RE: PERCOLATION TEST RESULTS, **A-525575**

### MEMORANDUM

RE: **Percolation Certification Plan**  
**12533 Folly Quarter Road, A525575**  
Map 22, Grid 23, Parcel 276 (structural addition)

**PERC CERTIFICATION PLAN**  
 PARCEL NO. 276  
**LESSING PROPERTY**  
 12533 FOLLY QUARTER ROAD  
 TAX MAP NO. 22 GRID 23 ZONED RR-DEO  
 5TH ELECTION DISTRICT HOWARD COUNTY, MARYLAND  
 SCALE: AS SHOWN DATE: NOVEMBER, 2006

ENCLOSURE: sketch existing system  
CC: file, Bill Demarco

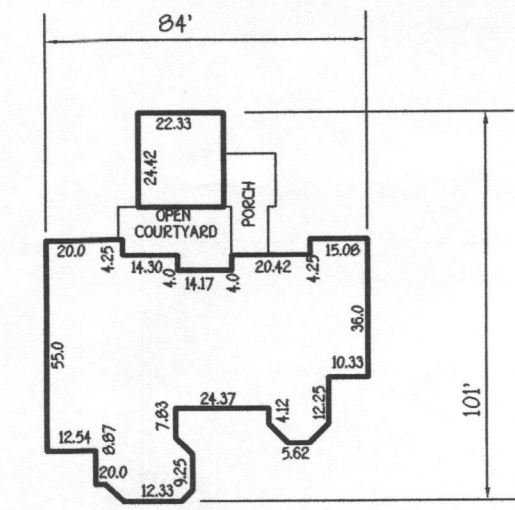
3. Existing septic system components need to be shown as accurately as possible.

a. The label for existing septic tank identifies the cleanout (c.o.) nearest to residence.

b. The cleanout at the fence is the existing dry well through which the effluent still flows.

c. The distribution box has not been shown on the Perc Cert Plan. There is a distribution box cleanout (4-inch diameter, white PVC, about 36" height) in the field, 10' from fence and inline between the dry well and two repair trenches.

d. Approximate locations for two ends for each of two 'repair trenches' were flagged in the field.

The end for one of the trenches is not shown. (Please show trenches as lines.)

e. The 'existing trench - approx. limit' is appropriately shown. (This was the fifth location flagged in the field.) Please show a trench from this flag location to the distribution box.

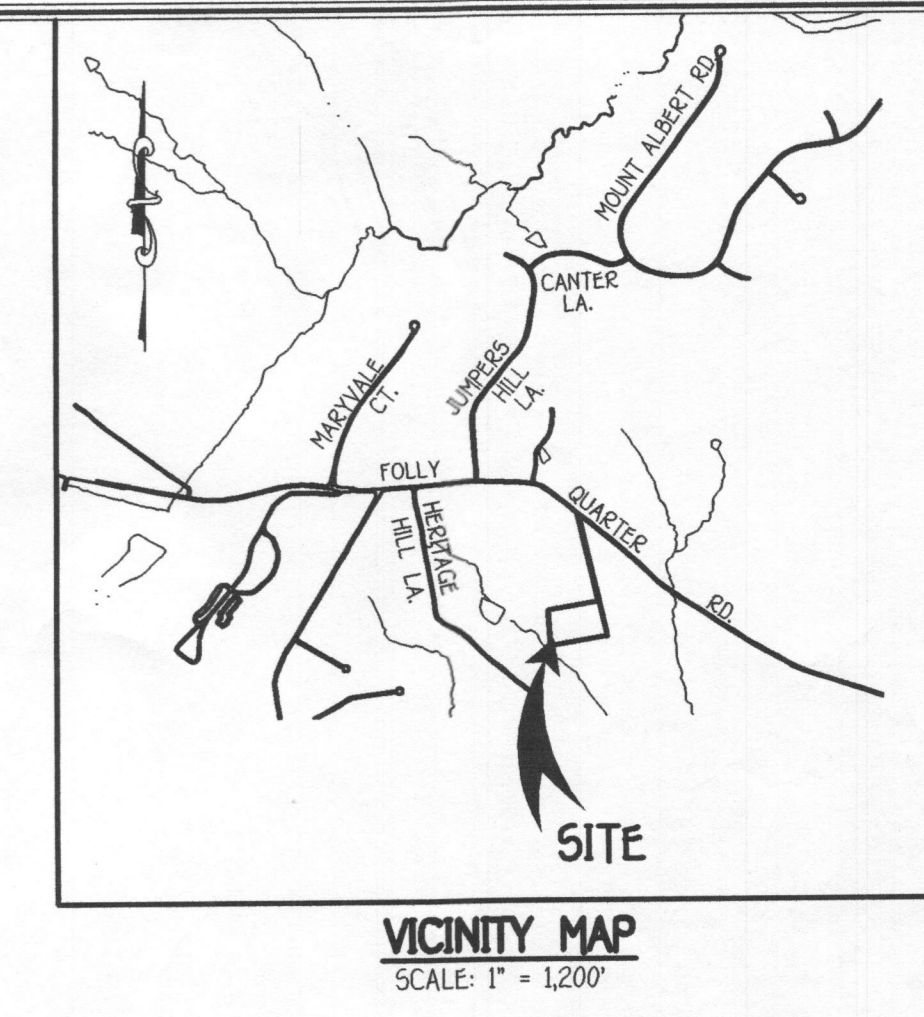
1. The values for 'Average time' and 'sq.ft. per bedroom' in the *Septic Trench Design Chart* are 12 minutes and 210, respectively.

2. Footprint of the planned addition must be shown on the perc cert plan.

4. References to elevation inverts are not needed on a Percolation Certification Plan. They will be shown on a Site Development Plan required for the Building Permit approval.

Similarly, proposed locations for new septic tank and/or new pump tank and new distribution box do not need to be shown on Perc Cert Plan. (I requested and you have appropriately shown the trench locations for three systems fitting into the septic easement. This will be helpful in gaining approval of the Perc Cert Plan, and the trench locations will need to be shown in the Site Development Plan as well.

5. Please include telephone numbers for 'Builder' and 'Owner'.

6. Include the (re: our) A# in the title block. For example the A# for this project (as it appears above): A525575
